BRADFORD NORTH 3RD ADDITION

Re: S/D 97-25 - BRADFORD 3RD ADDITION (Final Plat)

At the regular meeting of the Subdivision Committee of the Metropolitan Area Planning Commission on Thursday, May 8, 1997, the above captioned plat was considered. The action of the Committee was to approve the preliminary and authorize preparation of the final plat, subject to the following:

CASE NUMBER: S/D 97-25 - BRADFORD NORTH 3RD ADDITION

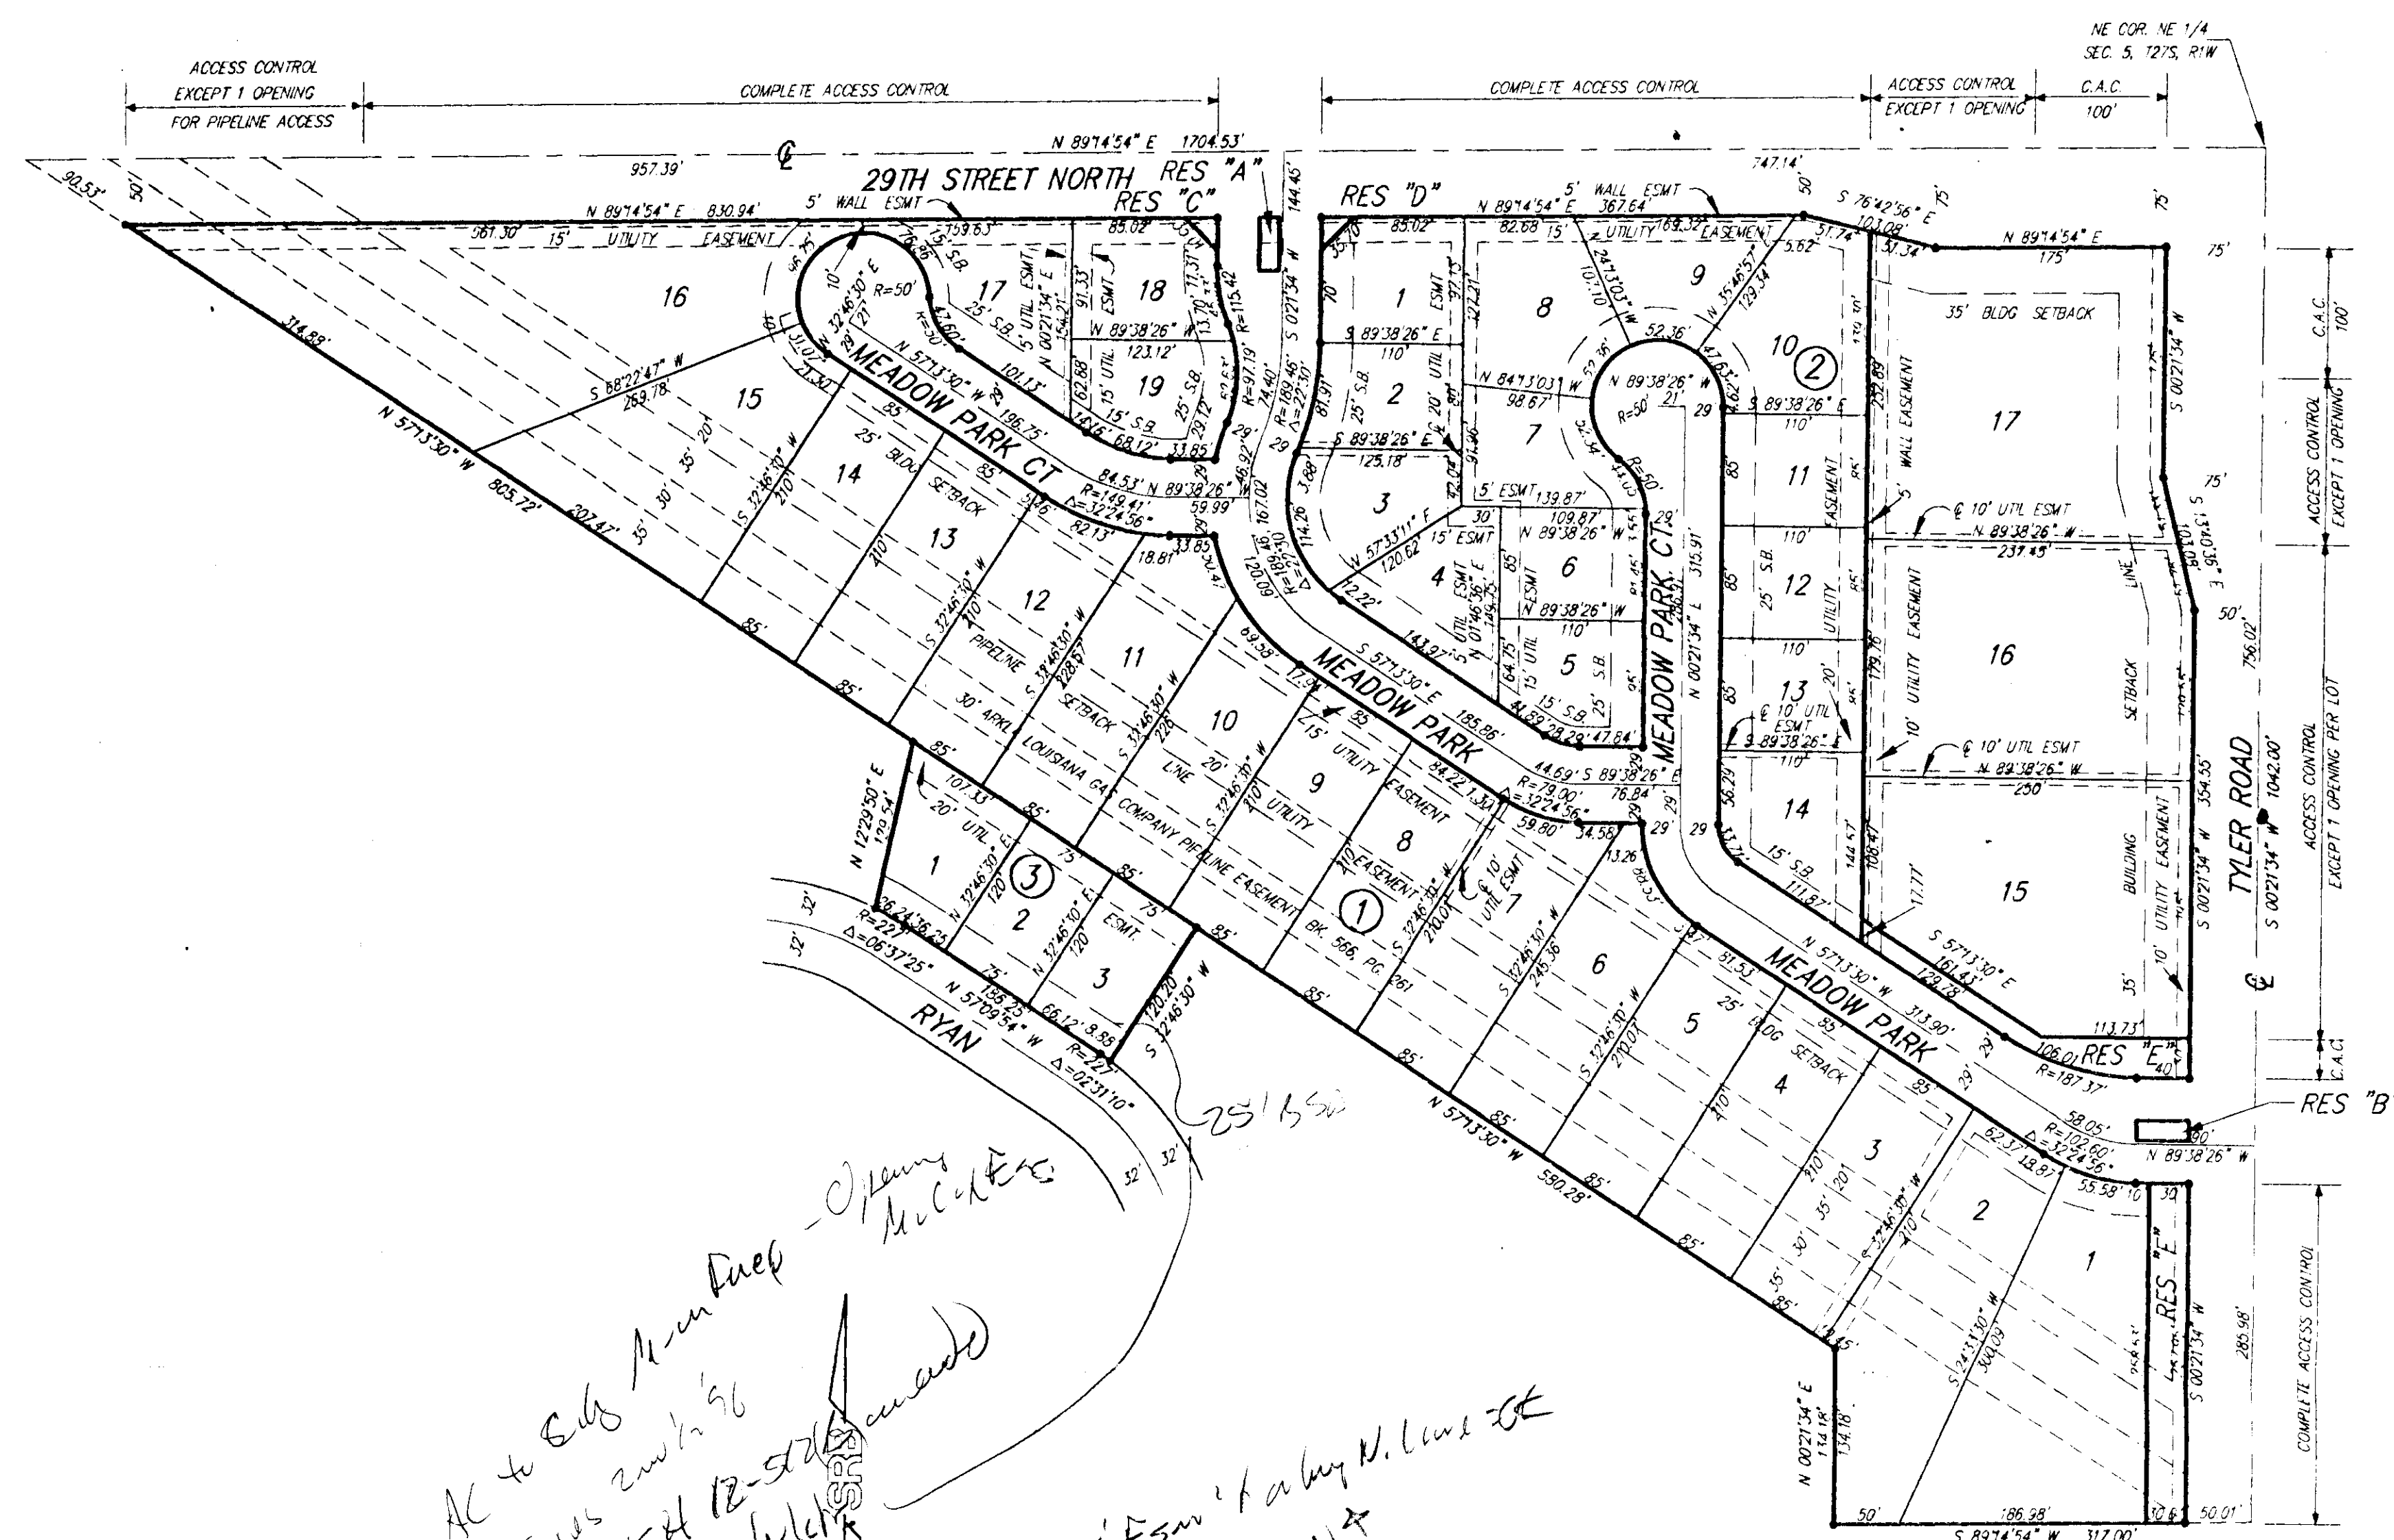
- B. ☒ The applicant shall guarantee the extension of sanitary sewer to serve the lots being platted. As requested by City Engineering, a sewer layout plan shall also be provided to City Engineering. If sewer is planned along the north line of this plat, City Engineering indicates the need for a 20-foot easement.

- K. ✓ Any relocation, lowering or encasement of the pipeline, made necessary by this development, will not be at the expense of the City.
- L. ✓ On the final plat tracing, dimensions from lot corners shall be shown for lots 1 and 16 in Block 1 so as to better locate the easements along these lots' side property lines.

- M. ✓ On the final plat tracing, the platter's text shall be revised to properly reference the dedication of access control. Specifically, the present wording should be expanded to note that the access control is being granted to the City of Wichita (as indicate in the face of the plat), with the location of openings to be approved by the City Engineer.

- N. ✓ Since this plat is replatting or vacating and replatting various public reservations, the surveyor's text should reference KSA 12-512 (b) as amended.

- O. ✓ On the final plat tracing, the building setback on Lots 1, 2, and 3, Block 3 shall be labeled.
✓ Below the north arrow, the legend shall also note that S.B. is for the Building Setback. Also, if the "control point" stands for iron or rebar set, the legend should also note that for the dot symbol.

- W. ✓ The representative from City Engineering indicated that the applicant's drainage plan has been approved and guarantees are required.
- X. ✓ KG&E indicated the need for easements along Lots 15, 16 and 17.
